# Stage II & ORVR and Associated Emissions of Gasoline Vapor State of Connecticut Gasoline Dispensing Facilities

Ted Tiberi, Luke Howard, Mike Heffernan, ARID Technologies, Inc.

18 December 2012

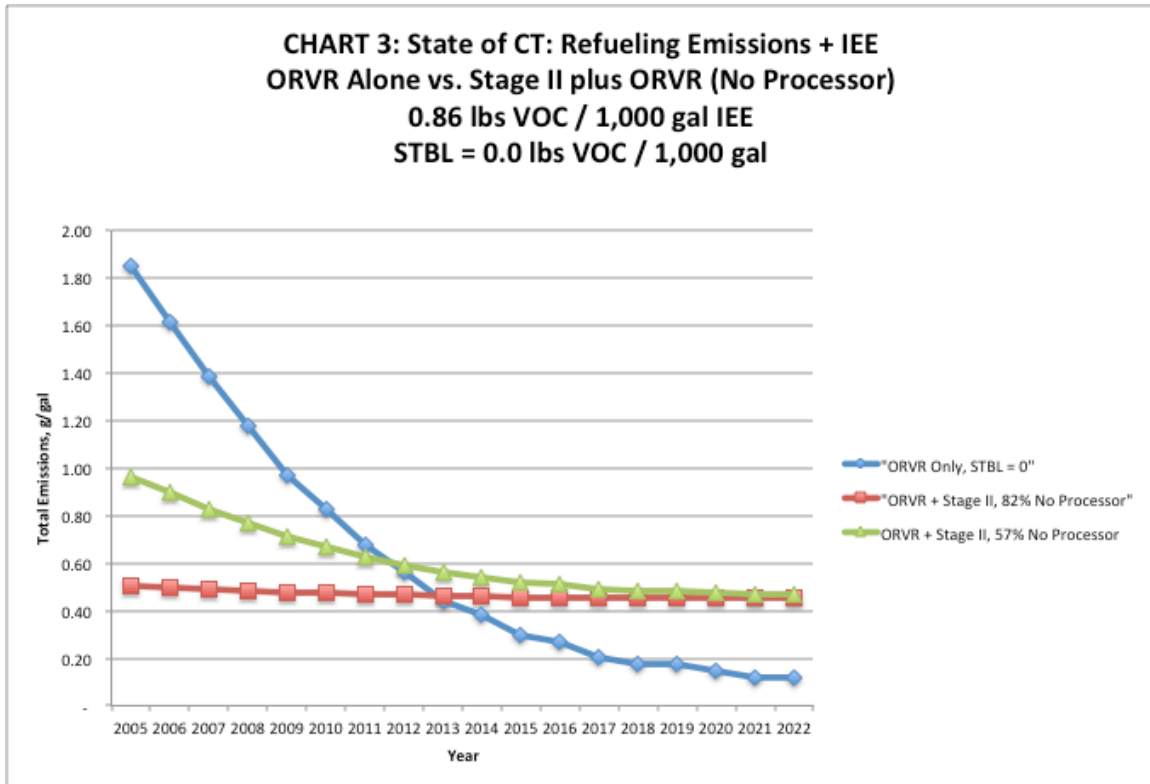
Next, we move to Chart 3, which represents the data from the dKC Report shown as Figure 4 on page 49. Here ARID recreates the dKC data by again using our simple spreadsheet instead of MOVES; incorporating the relevant dKC assumptions. First we plot ORVR Alone vs. Stage II plus ORVR, at the two Stage II efficiency levels. Even though ARID has directly measured values for IEE which far exceed the value of 0.86 lbs. VOC / 1,000 gal figure used by dKC for their Figure 4 plot; ARID uses the low figure in our Chart 3. Chart 3, if realistic, would show a benefit to using ORVR Alone beyond 2012 to 2013 (depending on Stage II efficiency).

However, the major problem with Chart 3 (and Figure 4) is that the Storage Tank Breathing Losses (STBL) for the ORVR Alone plot is **set to zero**. The assumption of zero STBL is totally unrealistic and not supportable by actual measured data. The STBL are a very important contribution to the total vapor losses, and the dKC Report (and US EPA rationale) have totally neglected this category of emissions. For decades, the USEPA has ignored this category of important emissions in their analysis of Stage II and ORVR interactions.

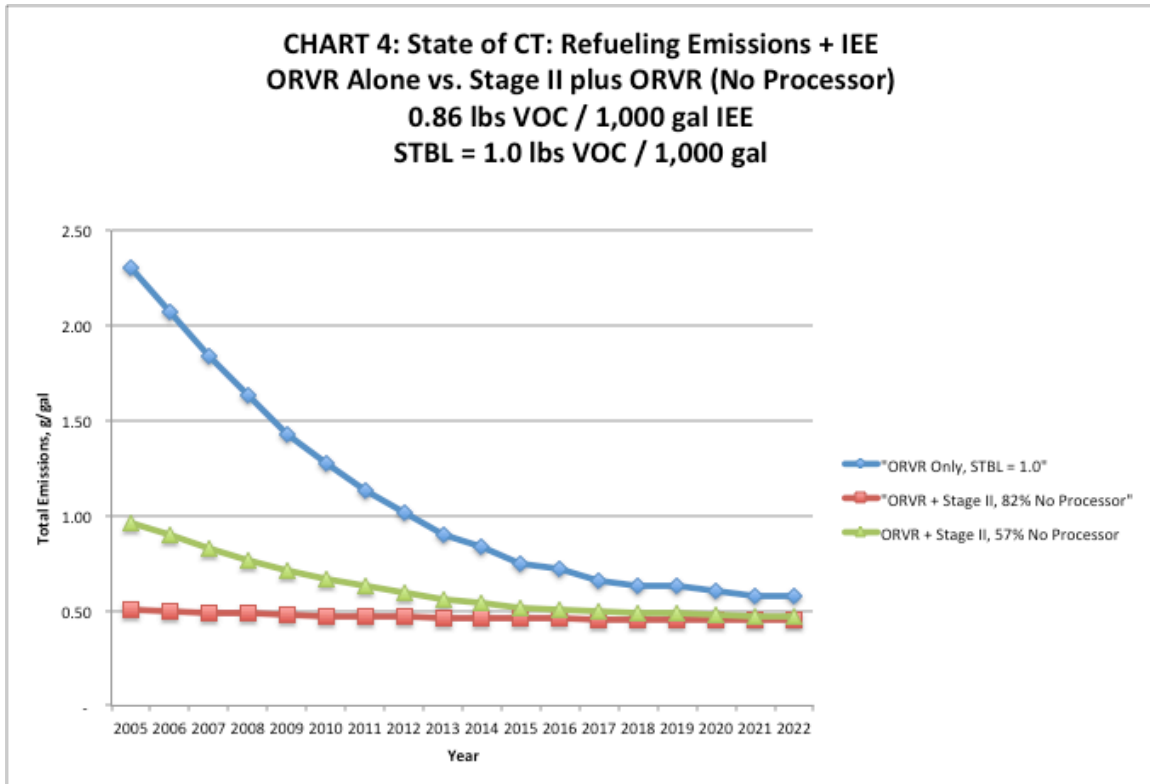
We incorporate a very conservative figure of 1.0 lbs./1,000 gal STBL in our Chart 4. Please note a gap between the ORVR Only emissions and the ORVR + Stage II emissions; there is no intersection of the curves and therefore no emissions reduction advantage to using ORVR Alone in comparison to ORVR + Stage II. Please also note that the emissions gap is relatively modest in future years. As a fair comparison, our Chart 5 now incorporates emissions curves for ORVR + Stage II + Vapor Processor; where an active vapor processor is used to control storage tank pressure and to reduce IEE by 99.3%, as confirmed by objective, third-party field testing.

**CHART 4a: State of CT: Refueling Emissions + IEE**  
**ORVR Alone vs. Stage II plus ORVR (No Processor)**  
**0.86 lbs VOC / 1,000 gal IEE**  
**STBL = 2.5 lbs VOC / 1,000 gal**

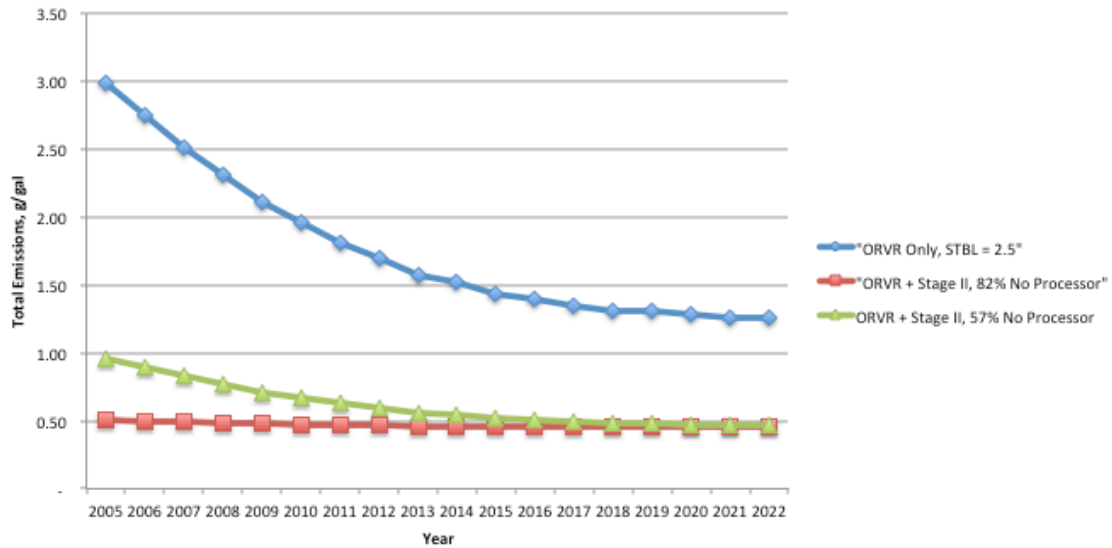
In Chart 4a, below; we incorporate a still conservative figure of 2.5 lbs./1,000 gal STBL. Please note that further “upward shift” in the ORVR only emissions curve.

**CHART 5: State of CT: Refueling Emissions + IEE**  
**ORVR Alone vs. Stage II plus ORVR (With and Without Processor)**  
**0.86 lbs VOC / 1,000 gal IEE**  
**STBL = 1.0 lbs VOC / 1,000 gal**

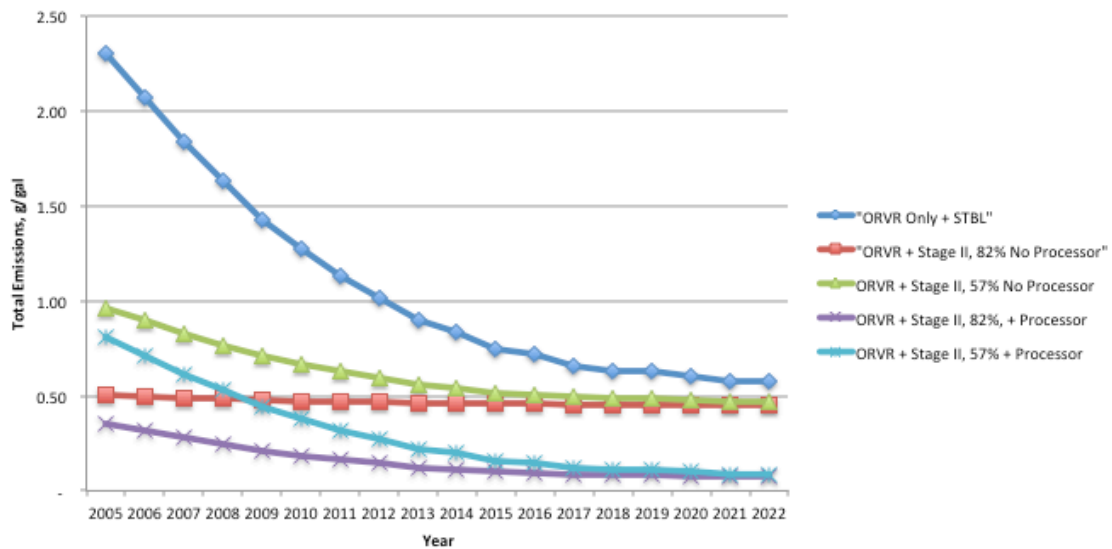
As seen in Chart 5, the ORVR + Stage II + Processor curves show a large reduction in total emissions from the ORVR Alone case, when STBL emissions are properly accounted for in the emissions inventory. We use a very conservative figure of 1.0 lbs. VOC / 1,000 gal for STBL; in practice ARID has measured values nearly five times higher than this figure, or about 5 lbs. of VOC per 1,000 gallons of fuel dispensed.

**CHART 5b: State of CT: Refueling Emissions + IEE**  
**ORVR Alone vs. Stage II plus ORVR (With and Without Processor)**  
**0.86 lbs VOC / 1,000 gal IEE**  
**STBL = 2.5 lbs VOC / 1,000 gal**

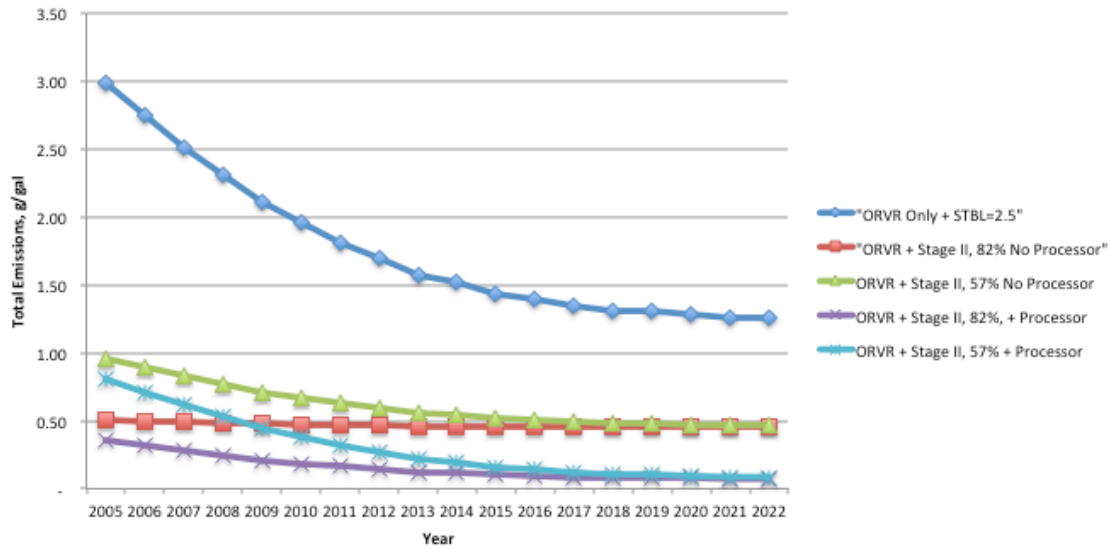
Chart 5b, below, shows the same curves but with STBL incremented to 2.5 lbs./1,000 gallons; still in our view a conservative figure.
